Commission of Architectural Review

7. COA-175479-2025	Conceptual Review	Meeting Date: 11/25/2025
Applicant/Petitioner	Andrae Austin	
Project Description	Demolish the rear of a single-family building and construct a new addition	
Project Location		
Address: 904 North 25th Street		
Historic District: Union Hill		
<p>High-Level Details:</p> <p>This application proposes the demolition of an existing one-story rear portion of the building, and the construction of a new rear addition at 904 N 25th Street. The primary two-story, 1868-block facing the street will remain, while the one-story, rear block is proposed for removal.</p> <p>The project also includes partial rehabilitation of the main façade, including restoration of original window openings, replacement of deteriorated windows with 6-over-6 units, and removal of non-historic vinyl siding.</p>		
Staff Recommendation	Conceptual Review	
Staff Contact	Yara Iwaz, Yara.Iwaz@RVA.gov, (804)646-6031

Overview of previous demolitions

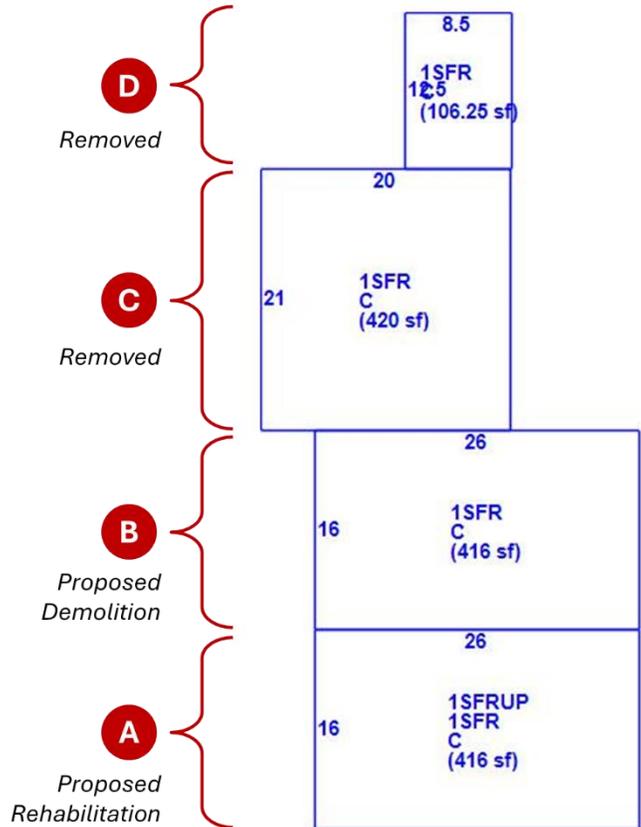
Staff reviewed historic maps, aerial imagery, assessor documentation, and available site photographs to establish a chronology of alteration and demolition on the parcel. The 1905 Sanborn map shows a detached rear building behind the 2-story street block; by 1925 the building footprint has expanded to include an attached one-story rear block that corresponds to the present Section B. Historic aerial and street imagery from **2004 through 2018** show the parcel retaining a rear complex consistent with the parcel-mapper sketch. **By 2020** the images indicate that two rear sections (corresponding to portions C and D in staff's analysis) had been removed. A conversation with the applicant confirmed

that the removal of portions C and D took place after severe deterioration of the building and following complaints from the neighbors.

While no formal demolition permits or acceptable permit records have been located for these removals, staff records and code searches did identify a related code case (016045-2018) documenting a “large amount of construction debris at the rear of the property”. Taken together the documentary and photographic evidence indicates that portions **C and D were removed from the property possibly around 2018 without permitting**, leaving exposed framing and temporary infill on the right side of the rear elevation. Interior photographs provided with the current application show remaining original siding and materials in portions of the rear block (indicating salvageable fabric may still exist on site).

Figure 10: Sanborn Map, 1905

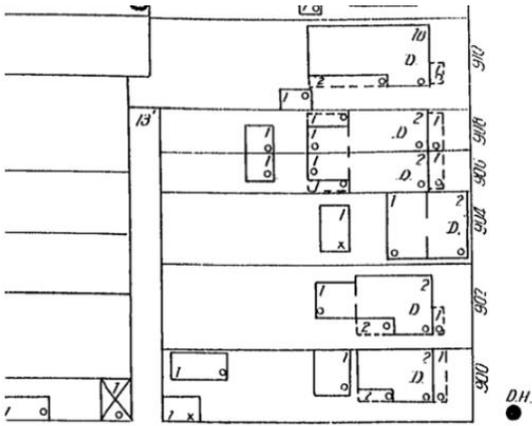
One interpretation of the above can be as follows: blocks A and B are originally constructed). Buildings C and D are constructed somewhere between 1905 and 1925. Buildings C and D are demolished in 2018.

Based on the Sanborn maps (1905 and 1925) and photographic evidence, the rear one-story portion (Section B) now proposed for demolition is suggested to be original to the 1868 structure. The earliest conclusive evidence of the building suggests the main historic resource is the front 2-story block and the attached 1-story block, while rear portions evolved through secondary expansions and later removals.

Figure 11: Sanborn Map, 1925

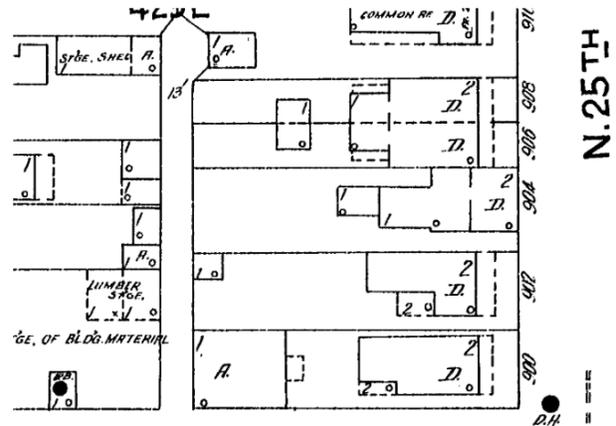
- Section B appears on the 1925 Sanborn map and thus is at least early 20th-century in age; it therefore represents historic fabric that contributes to the building’s multi-phased evolution.
- Section B is physically connected to the 1868 front block (Section A) and the roof and wall relationships negatively influence stormwater management and structural integrity of the front elevation. Photographic evidence shows that roof valleys and water runoff at the junction have produced deterioration that affects both the rear block and nearby primary fabric.
- Exposed and boarded areas on the right side of the rear façade indicate past unsanctioned removals; remaining original siding and other materials were observed and may have salvage value.

Section B is demonstrably historic in that it appears on the 1925 Sanborn map and potentially retains historic material in places. Portions C and D were removed possibly between 2018 and 2020, leaving the rear elevation partially infilled and in compromised condition. The front block (Section A) **remains the primary character-defining element and must be prioritized for preservation and high-quality rehabilitation.**
